ASTRA RROCI Satellite
0867-EX-CN-2022
Supplemental Responses January 27, 2022

The following pages contain information that responds to questions posed to ASTRA by the FCC in messages sent on January 13 and January 20, 2022.

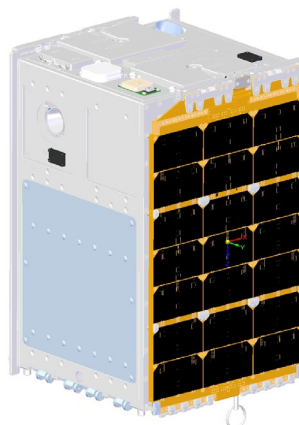
4) In attachment A, please explain the 5 provided cross-sectional area values. What does each of these values represent in a real-world scenario?

The cross-sectional areas in Attachment A show the relative area of the vehicle facing the velocity vector, modified by tuning the angle of the solar panels with the velocity vector. Both panels can rotate independently to modify our drag profile as needed, and in the event of a thruster failure, would be locked into the highest drag profile possible to reduce our orbit lifetime in the 5.23 years shown in the analysis in Attachment A. In real-world, the cross-sectional areas are applied as shown in the following figures. The below figure shows the spacecraft in its stowed state, with the panels folded down against the spacecraft body.
